### Section 3.4 Wildlife

Silo Ridge Resort Community  
Master Development Plan  
**REDUCTION OF SINGLE FAMILY  
HOMES IN BLOCK 'H' AREA**  
Town of Amenia, Dutchess County, New York

SCALE: 1"=80'  
**Figure  
3.4-1**

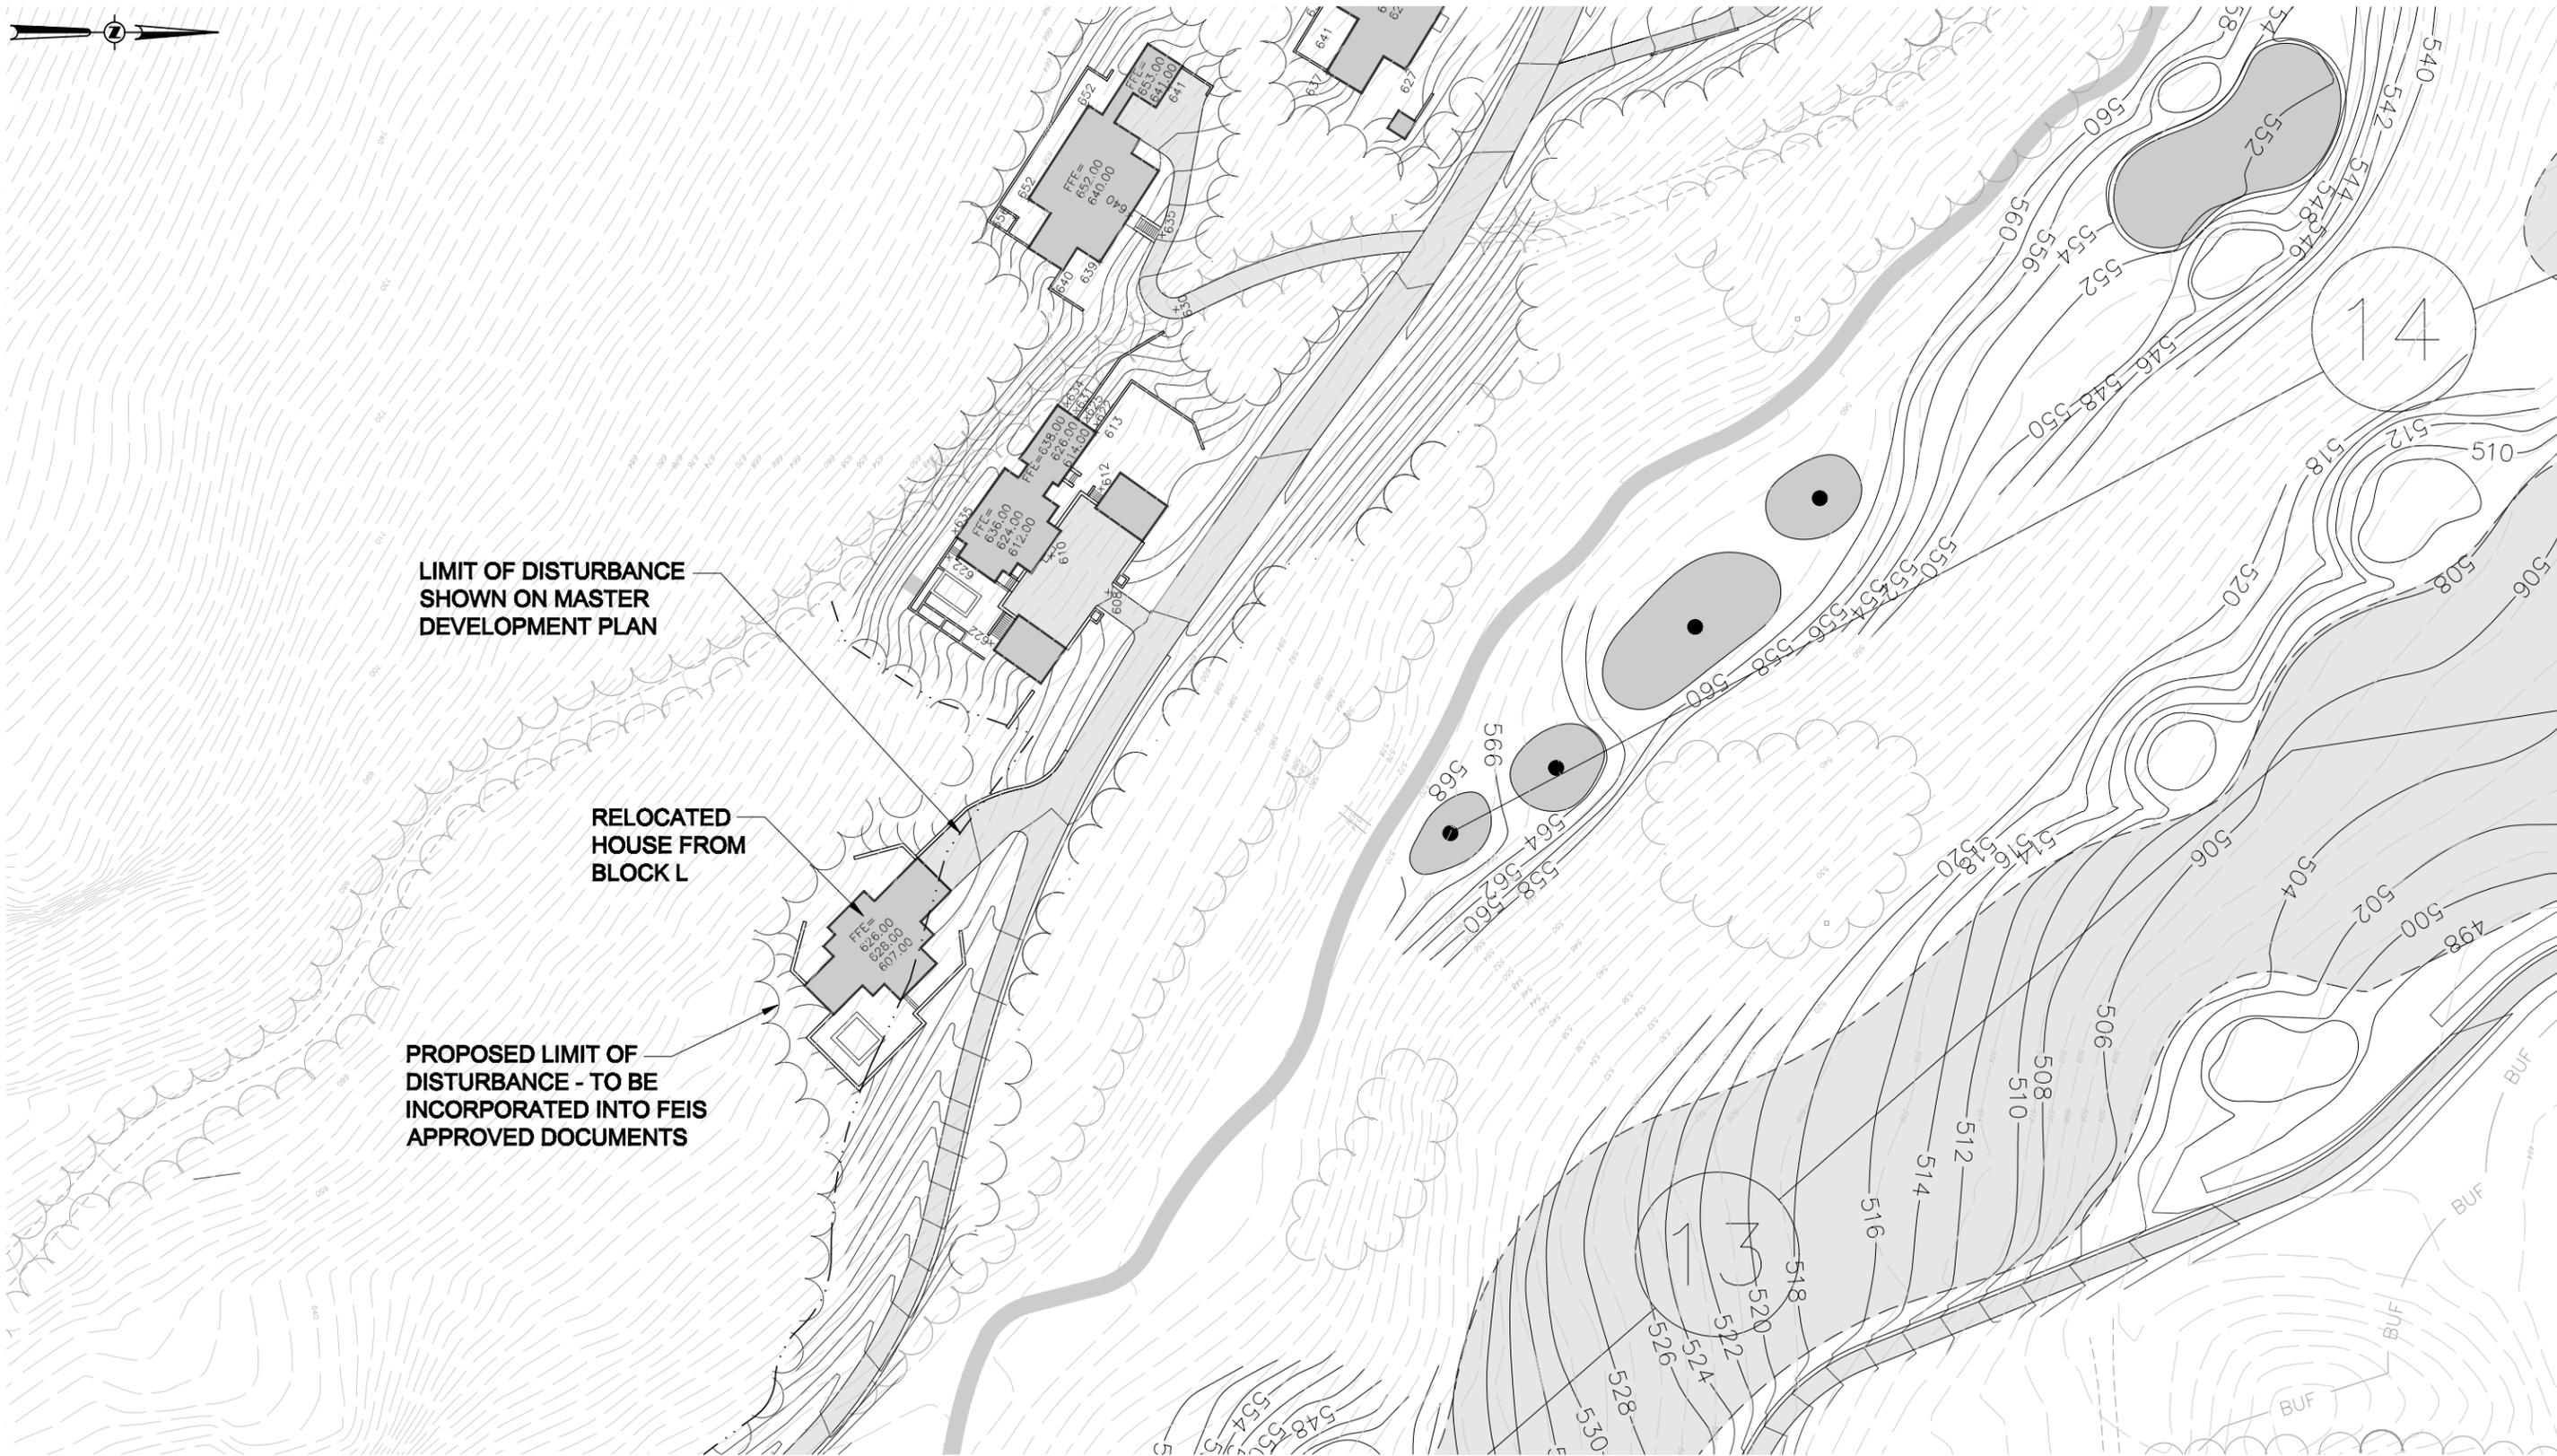
**Comment 3.4-5-34H:** Regarding DEIS page 3.4-9 and Table 3.4-3. The dusky salamander (*Desmognathus fuscus*) is a regionally rare species in Dutchess County. Once widespread, populations of this species have plummeted throughout the mid-lower Hudson Valley because of the deterioration of stream quality, particularly increases in flashiness, scouring, and thermal alterations associated with development activities. The documentation of this species in the headwaters of area of Stream J is particularly significant on this site. It points to the spring-fed nature of the headwaters area, which is another critical component of dusky salamander habitat. A special conservation zone should be established in that area, and more work is needed to determine the extent of the population within this spring fed seepage area. I would also recommend that the pod of development that is proposed around this wetland area be eliminated or relocated elsewhere. [Dr. Michael W. Klemens, LLC, Letter, March 18, 2008, Comment H, page 2]

**Response 3.4-5-34H:** It is understood that Stream J and its headwater wetland are important dusky salamander habitat. In consultation with the Town's Consultants, the Applicant reevaluated the development around the areas identified by Dr. Klemens as being important for the dusky salamander. Figures 3.4-1 and 3.4-2 illustrate the relocation of buildings so that they are more than 100 feet from the portion of Stream J containing this habitat. Additionally, a Habitat Management Plan (Appendix F) has been prepared and is included with this FEIS. The Plan includes a Buffer Management Plan which addresses buffers that will be created around Stream/Wetland J. This Plan also describes the value of the buffer and how it will be preserved and maintained to enhance the dusky salamander habitat. The development proposed around Stream/Wetland J has been designed so as to avoid the wetland as much as possible, while still accomplishing the project goals.

SCALE: 1" = 250'  
**Figure 3.4-3**  
JOB NUMBER: 10454.02

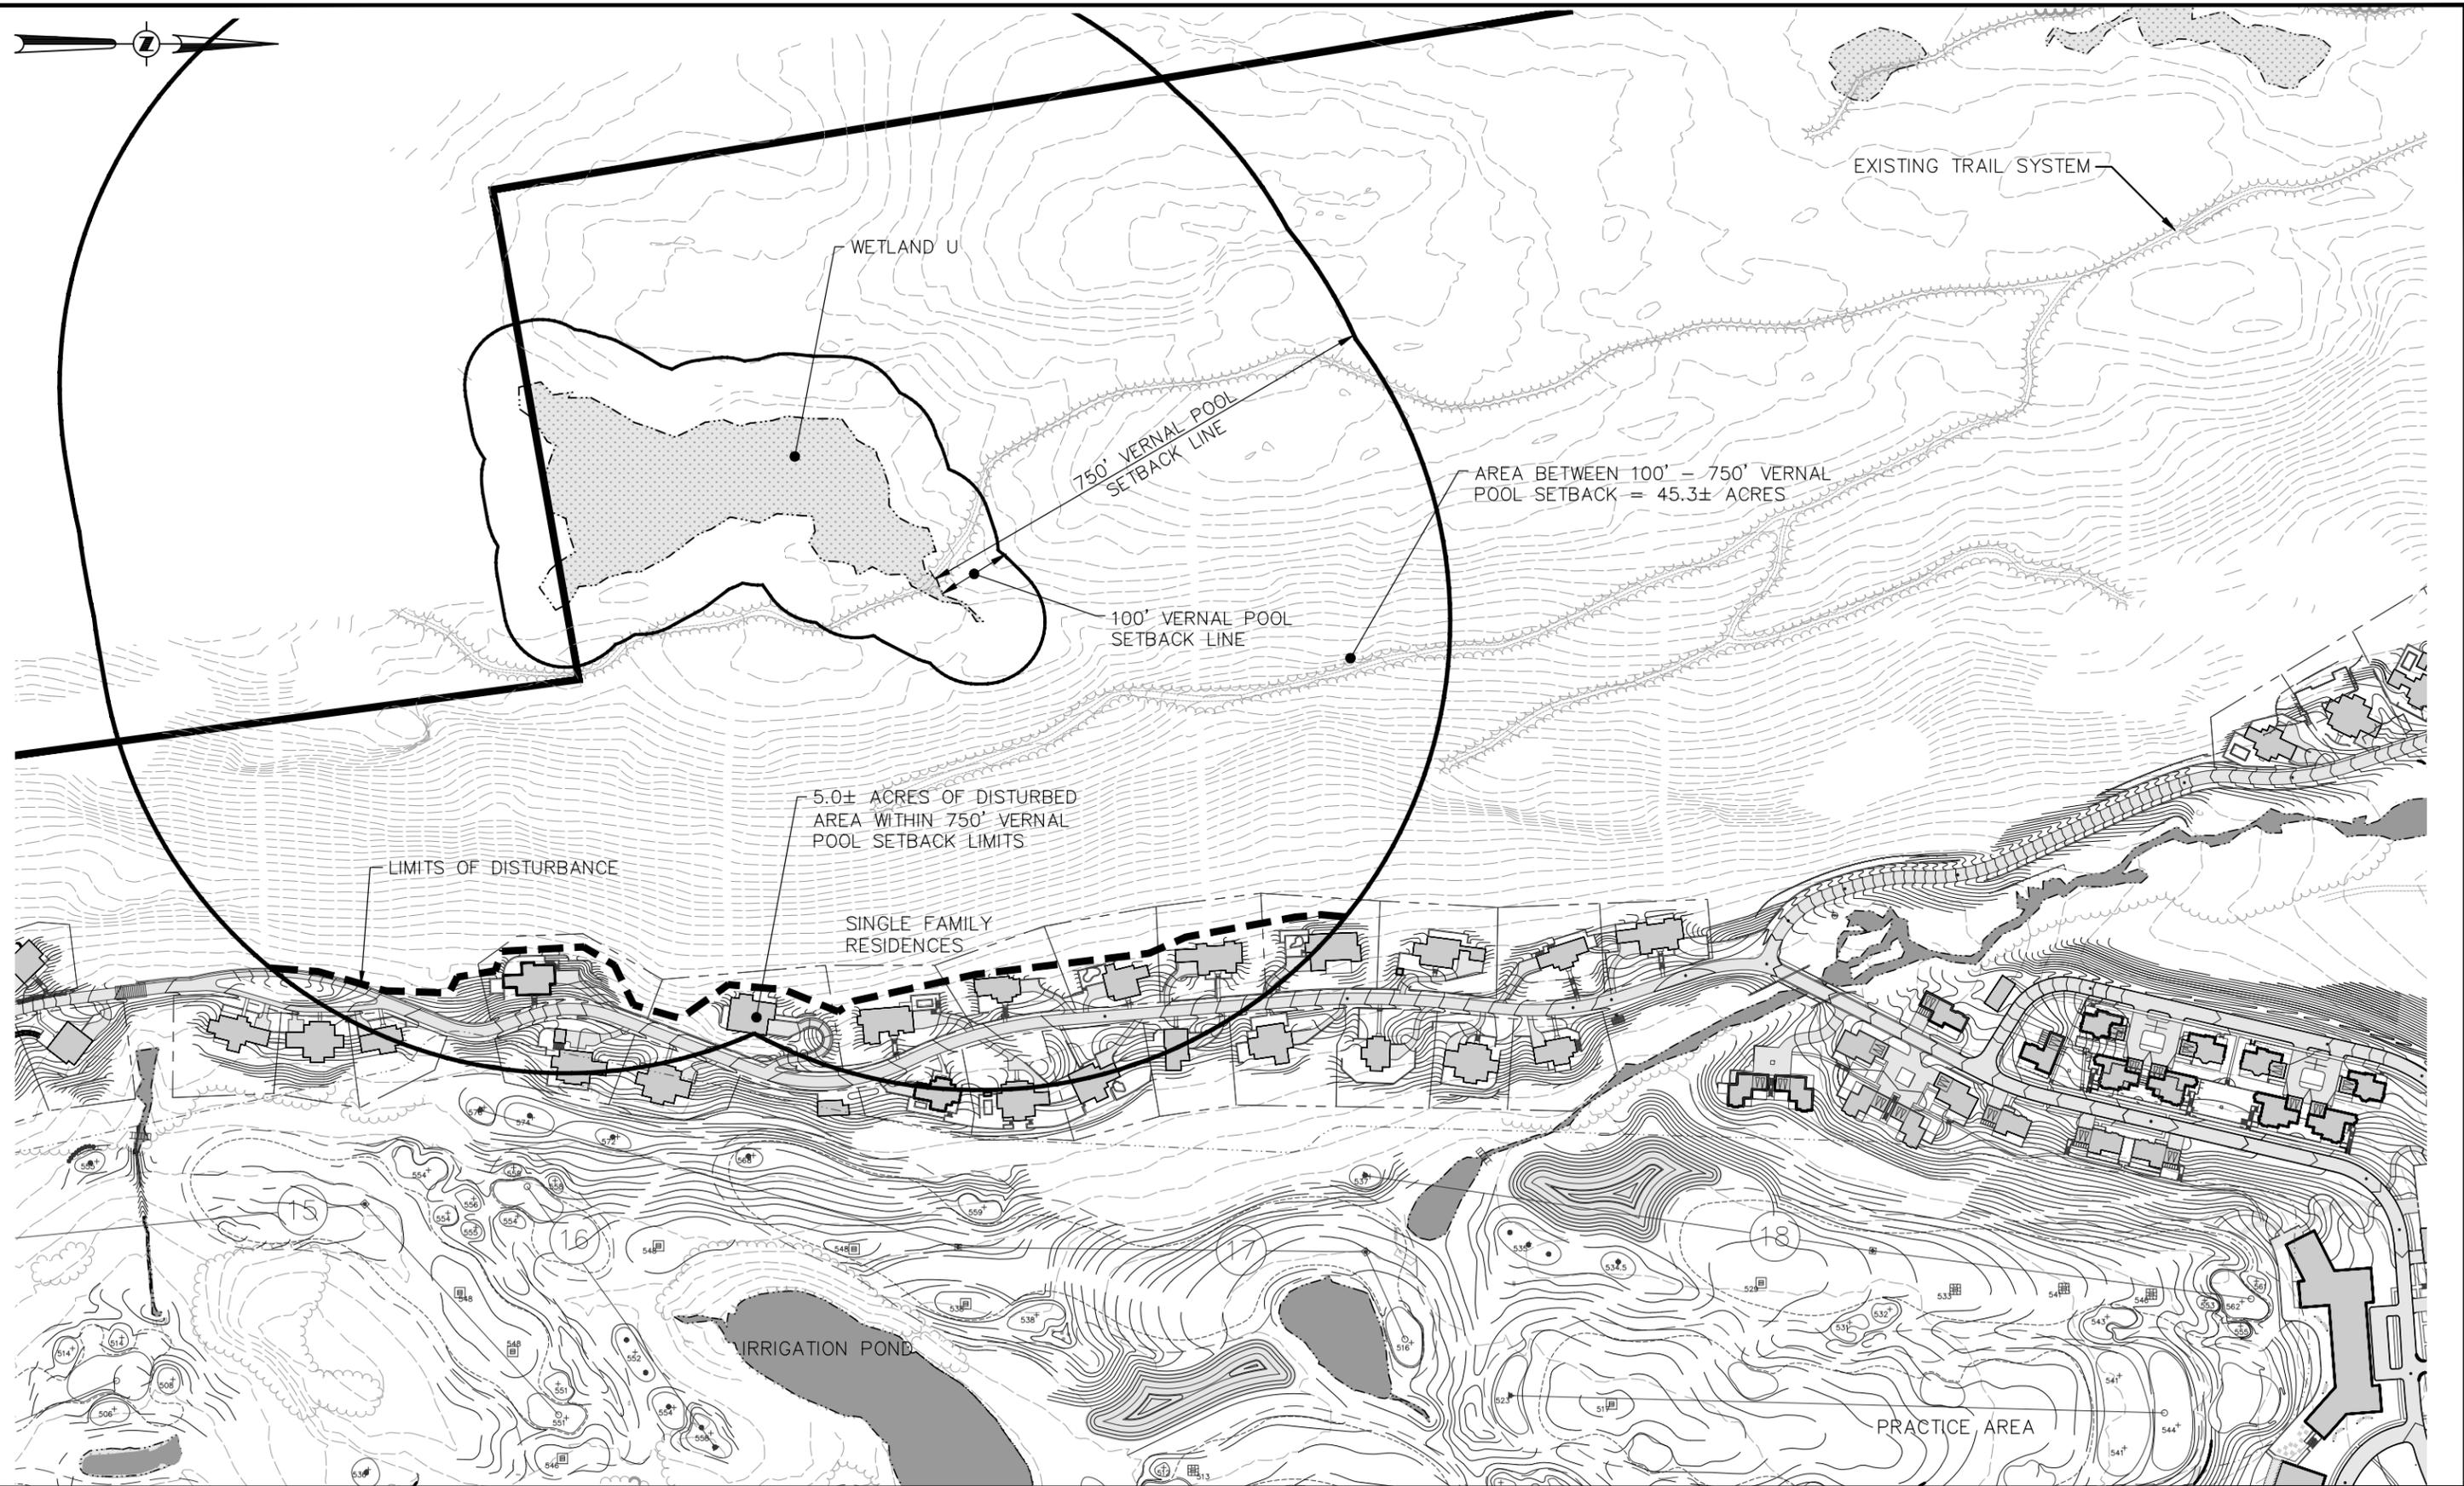
**Comment 3.4-6-34F:** Regarding DEIS page 3.2-24, vernal pools. While I agree that the Applicant has avoided impacts to Wetland U by the design of the project, I disagree with two unnecessary statements that are included in the text. The steep drop of 350 feet is likely not an impediment to amphibian movements as these lightweight sticky creatures are often able to scale vertical or near vertical surfaces. The discussion that vernal pools are not protected by either State or Federal law is a red herring. The rich biota of vernal pools are a consideration of the Board's SEQRA review, therefore they have full standing to be considered in this Board's review of the proposed project. [Dr. Michael W. Klemens, LLC, Letter, March 18, 2008, Comment F, page 1 and 2]

**Response 3.4-6-34F:** The errata section (Section 2.0 of the FEIS) notes that the two statements identified by Dr. Klemens have been removed from the record. Vernal pools fall under the category of “Special Management Zones” and are covered in section 4.1.2.4 of the NRMP (Appendix 9.11 of the DEIS). Figure 3.4-3, “Vernal Pool Setback Map,” illustrates the vernal pool setback zone. There is no development proposed within 100 feet of the vernal pool. There are approximately 45 acres on the project site between 100 and 750 feet from Wetland U. Of these 45± acres, approximately 5 acres (or 11%) will be impacted by development; this development is located at least 500 feet from Wetland U.
